## ADDENDUM NO. 1

PROJECT: ***REGION 2 HEADQUARTERS LAB REMODEL***

FWP PROJECT #: 16-14

ADDENDUM DATE: June 2, 2016  
BID OPENING DATE: June 9, 2016, 3 PM

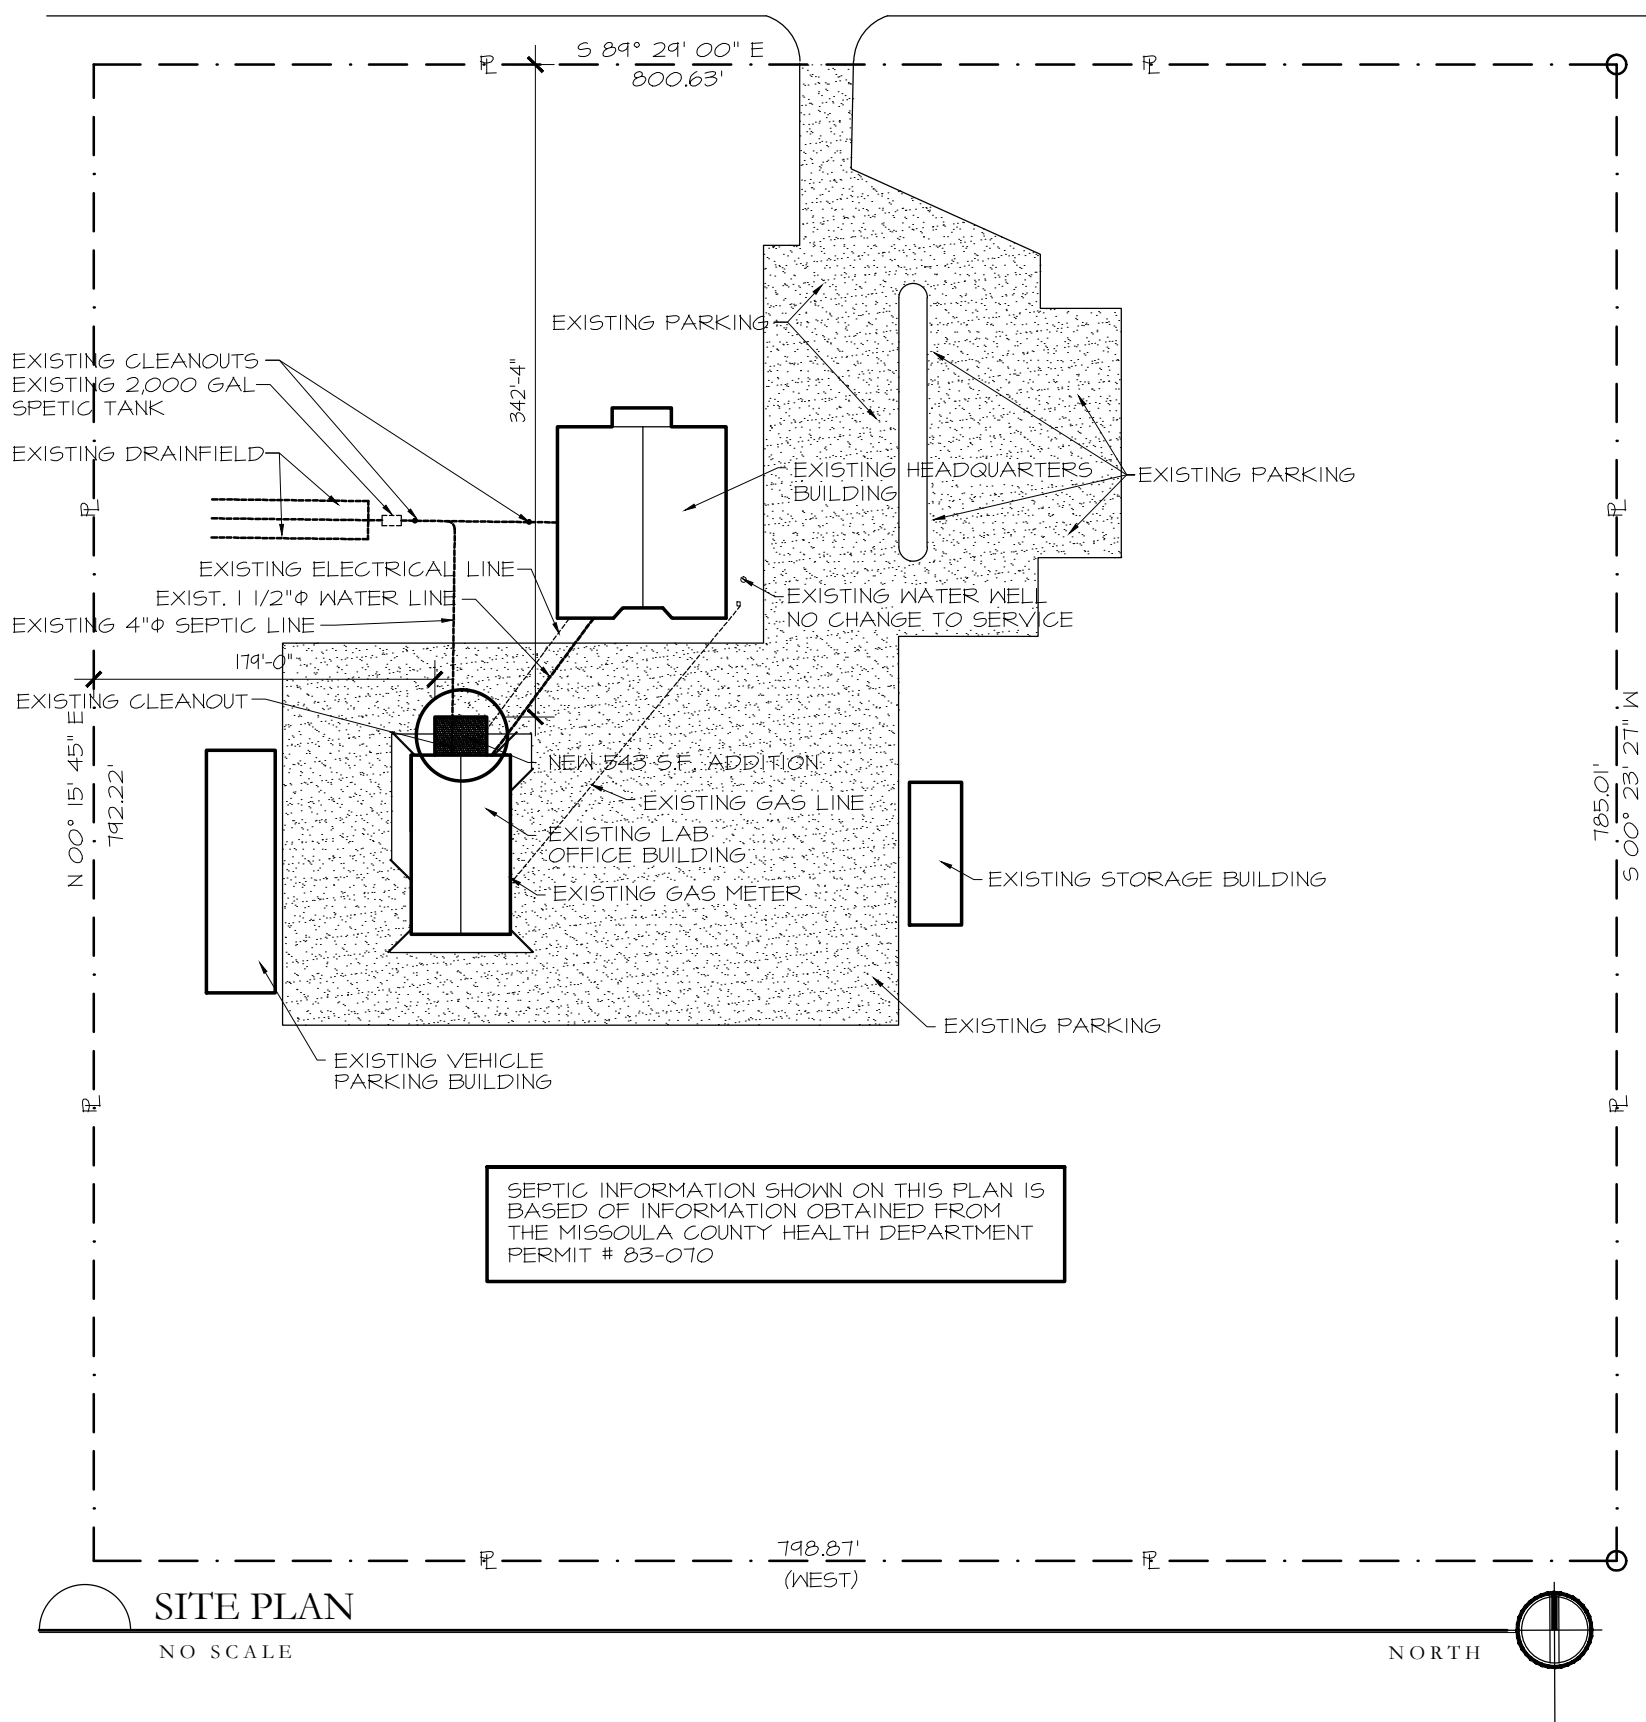
1. Additional utilities exist in the area of the remodel and addition. Utilities include gravity sewer, water, electrical and possibly fiber optic and phone. The assumed locations of these utilities are shown on the attached drawing. Contractors need to be aware of these utilities and make adjustments accordingly including possible sleeving of utilities at the foundation wall.
2. The location of the proposed sewer cleanout, shown in Drawing A-3, should be moved to a location north of the addition wall, per code.
3. The proposed sewer cleanout shall be placed within a traffic rated frame and cover.
